Deep Creek Quarry Response to Submissions Report

Limeburners Creek, New South Wales

Rev 1
23 December 2022

Project Details	
Project Number	SSD 11591659
Project Name	Deep Creek Quarry
Address of the land in respect of which the development application is made	279 Deep Creek Road Limeburners Creek NSW 2324 Lot 472 DP 1162208 & Lot 48 DP 753178, Lot 551 DP 1238818 & Lot 12 DP1277150
Applicant Details	
Applicant Name	Ironstone Developments Pty Ltd
Applicant Address	PO BOX 2185 GREENHILLS, NSW 2323
Document Prepared By:	
Name	Jonathan Berry
Organisation	
Qualifications	B.AppSc (Hons), MEIANZ
Role	Lead Author
Address	PO Box 234 Cardiff 2285
The undersigned declares that this Document: • this document contains a Response to Submissions document • contains all available information relevant to the Response to Submissions for the activity or infrastructure • does not contain information that is false or misleading • addresses issues raised in the submissions received on the project • contains a simple and easy to understand summary of the project as a whole, having regard to the economic, environmental and social impacts of the project and the principles of ecologically sustainable devel

Quarry Site Plan North - Stockpile Area

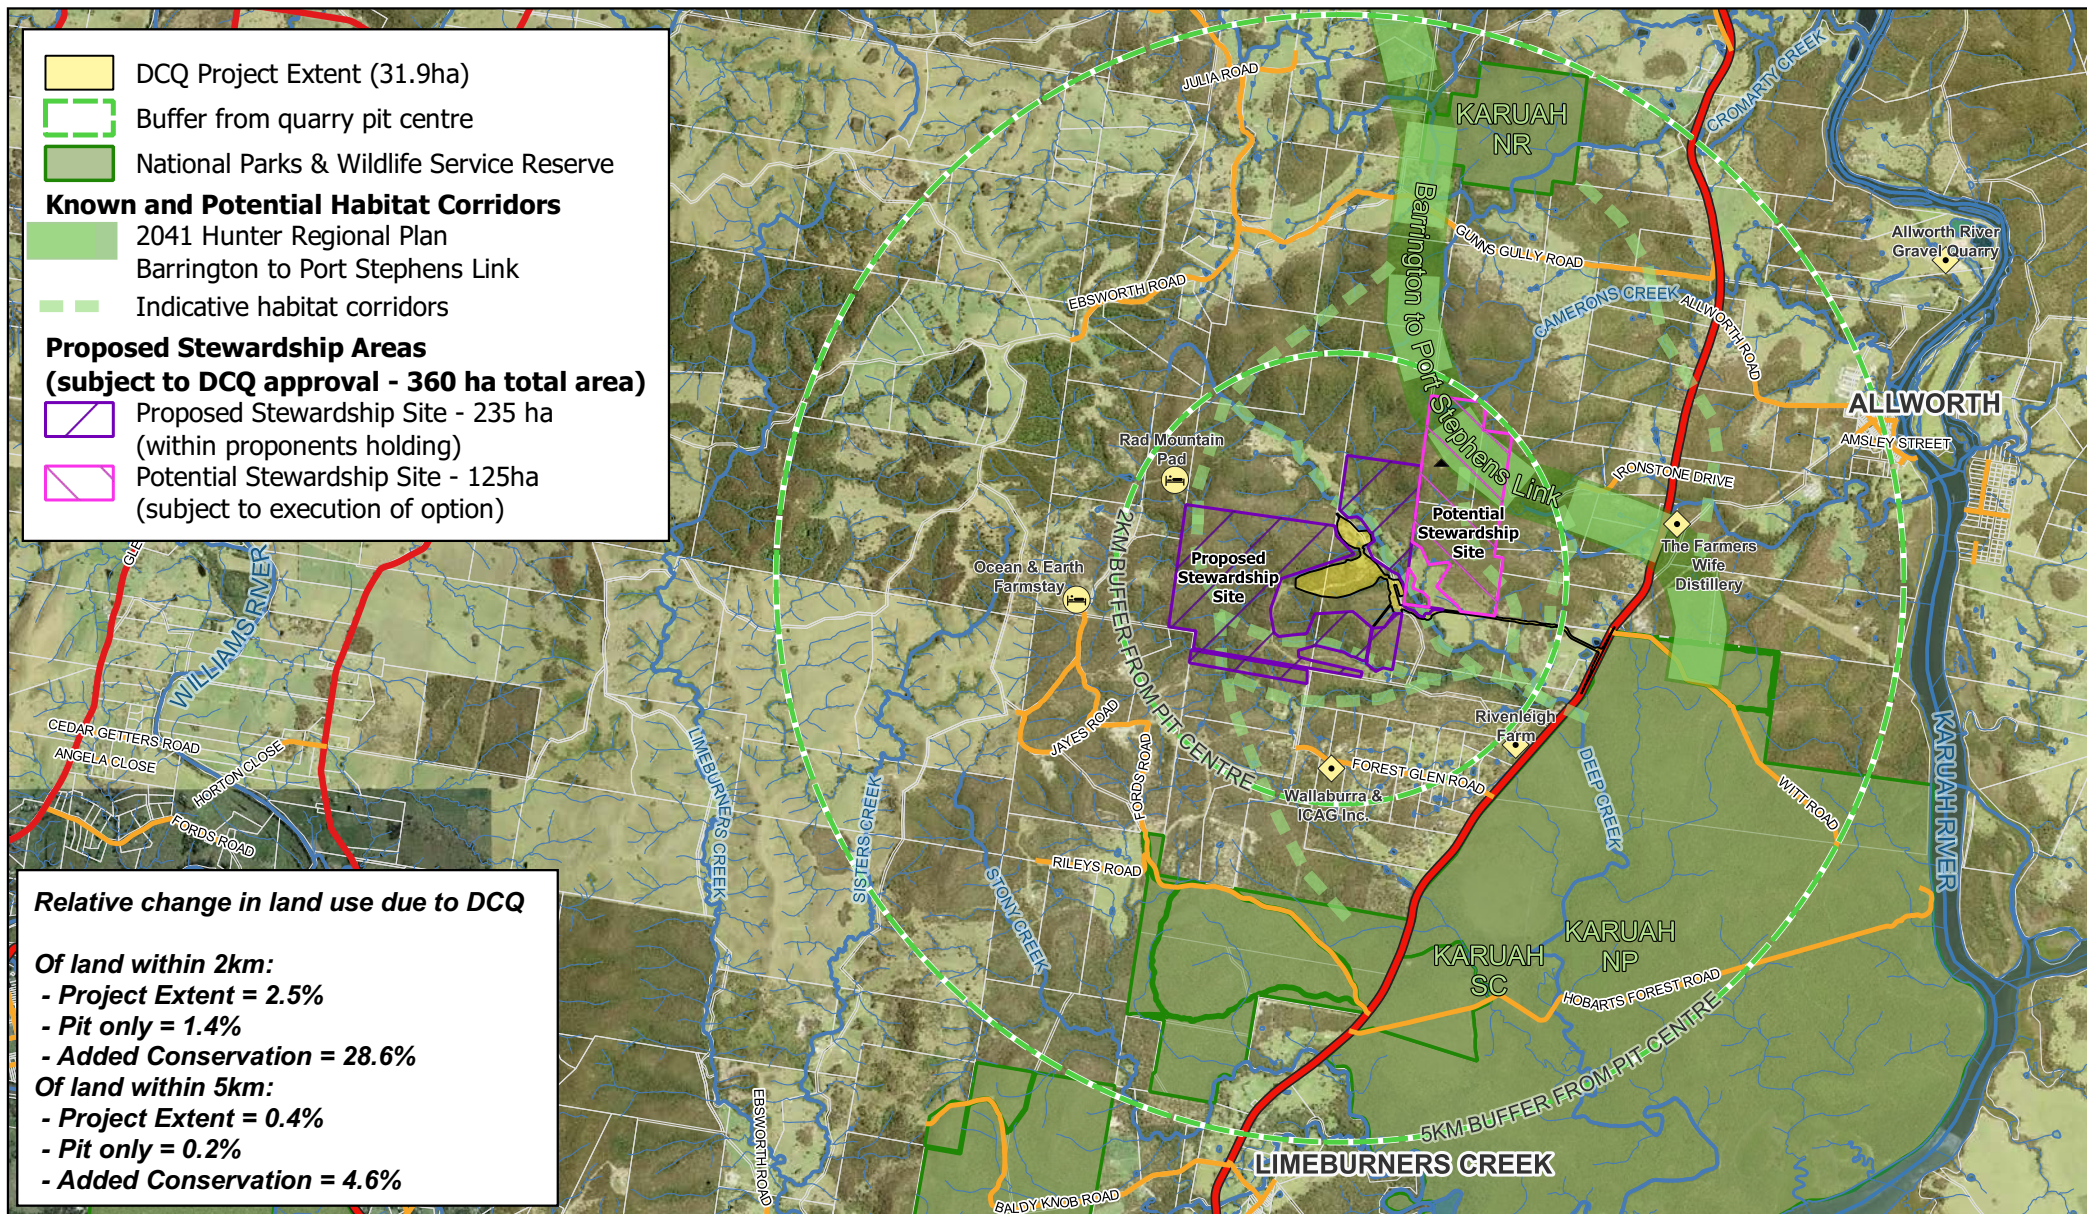
A review of waterfront land was undertaken, with the increased size of sediment basins proposed to reduce the occurrence of discharge from sediment basins, it was not possible to maintain all basins outside the 40m riparian buffer. The Office and Workshop Area sediment dam is located outside the 40m riparian area, however the Stockpile Area sediment dam does intersect the 40m riparian buffer with a disturbance area of approximately 1600m² of the outer riparian zone (20-40m from the Deep Creek bank). The intersected area is within a largely cleared paddock and will remove several paddock trees and remains above the bank of Deep Creek. Several areas are available within the proponent's landholding to increase the vegetated riparian corridor to compensate for the incursion, refer to **Figure 3-5** for the an indicative location of planting.

Within this estimated 2.9 ha of land planned for planting of PKFTs, approximately 1,600m² will satisfy the incursion (from the stockpile sediment dam) of the same size in the outer riparian zone (i.e., 20-40m from the Deep Creek bank), consistent with the *Guidelines for riparian corridors on waterfront land* (2012).

Refer to **Figure 3-5** for the indicative areas of planting and riparian corridor offset.
